TITLE: BA-660 Mic Pre/Limiter

| CODE: | SIZE: | DRAWING NO: | REV: |
|---|---|---|---|
| | | MIC PREAMP | 3.13 |

SCALE: SHEET: 3 OF 12

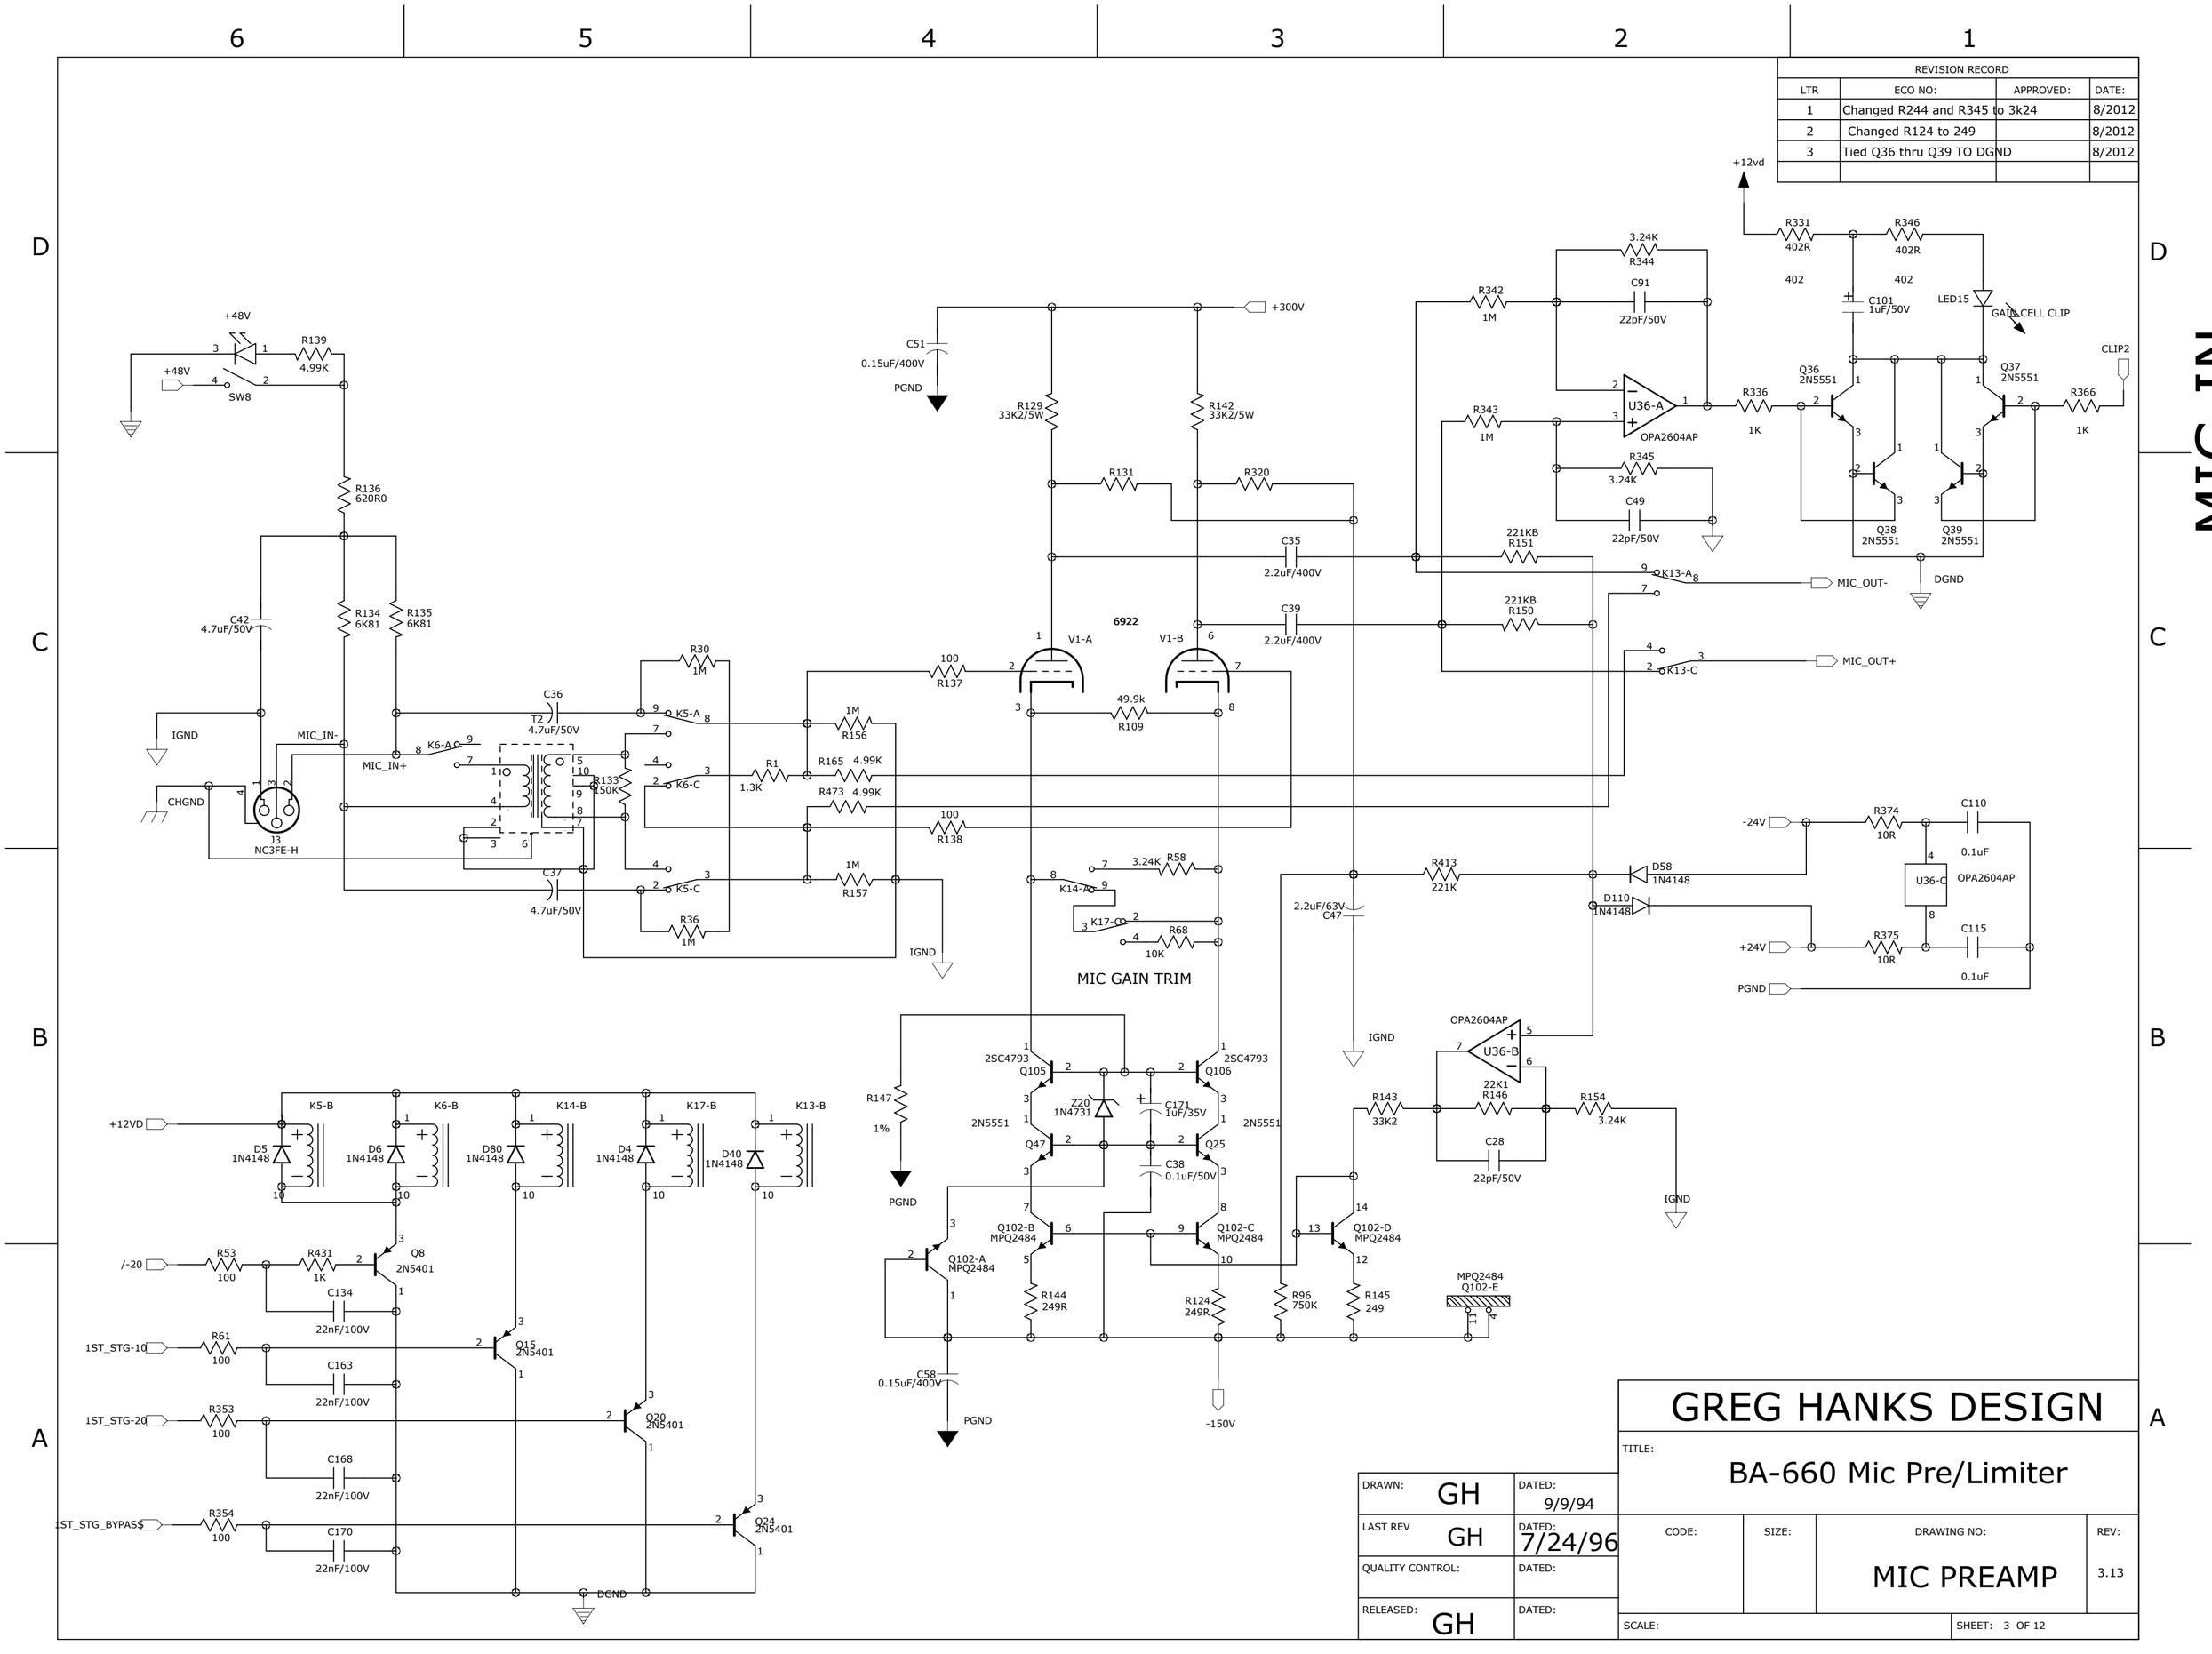
| REVISION RECORD | | | |
|---|---|---|---|
| 1 | Changed R244 and R345 to 3k24 | | 8/2012 |
| 2 | Changed R124 to 249 | | 8/2012 |
| 3 | Tied Q36 thru Q39 TO DGND | | 8/2012 |
